WATTS BAR NUCLEAR PLANT (WBN) – DAM SAFETY INSPECTION RESULTS AND FUTURE SCHEDULING UPDATE

**Dam Safety Inspection Report - Class A
Watts Bar Hydro Plant
Special, Nuclear Yard Drainage Holding Pond**

File Number: 91-00
EDMS Number: J22 080807 001
UNID: WBH-00-INSP-333 -DAM
Report ID: R00WBHCLA082008

Date of Inspection: 07/18/08

Figure 4:
View of upstream side of dam with the concrete spillway. Note numerous trees that will need to be removed.

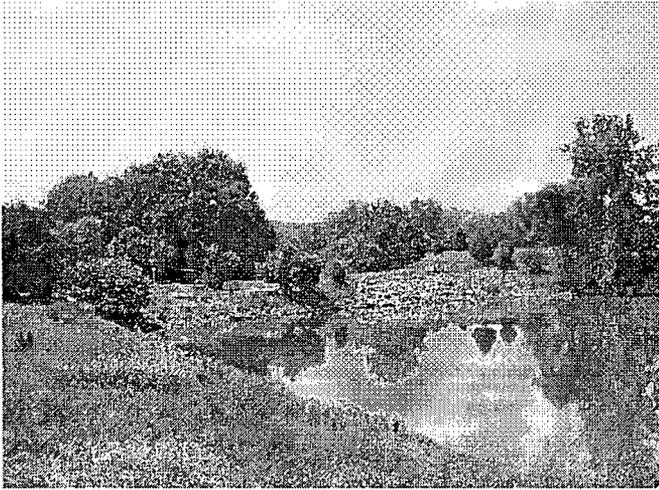
The embankment dam is in satisfactory condition. Numerous trees will require removal per Dam Safety requirements. See Exhibit 1 for recommendations.

1. PM – Remove the trees located on the upstream and downstream side of the small embankment dam and spillway. Include all trees within 20' of the toe and groin areas.
Responsible Organization: Facilities Maintenance, Darrel Reed
Estimated Cost: \$4,000.00
Estimated Completion Date: 3/30/09

Figure 8:
View of a small hole that has undermined the
concrete spillway slab.

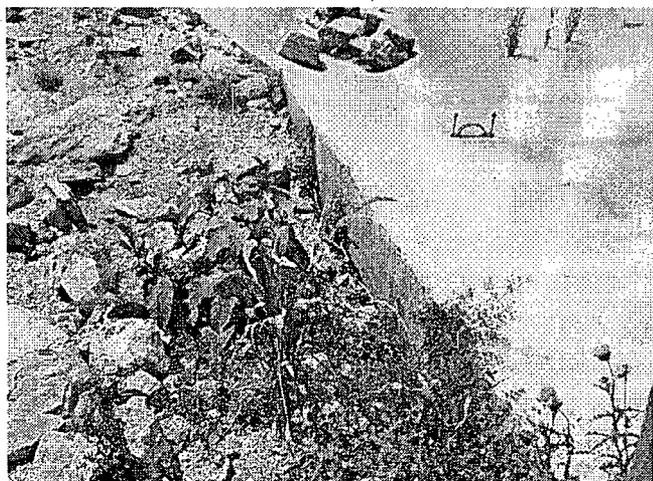
The spillway section is in satisfactory condition. A small undermined area is located on the left side of the spillway slab, which allows water to flow underneath the slab. This hole should be filled with small 1/2" stone. See Exhibit 1 for recommendations.

2. PM – Fill the small hole that is undermining the left side of the spillway slab just downstream from the crest of the dam with small 1/2" washed stone.
Responsible Organization: Facilities Maintenance, Darrel Reed
Estimated Cost: \$500.00
Estimated Completion Date: 3/30/09
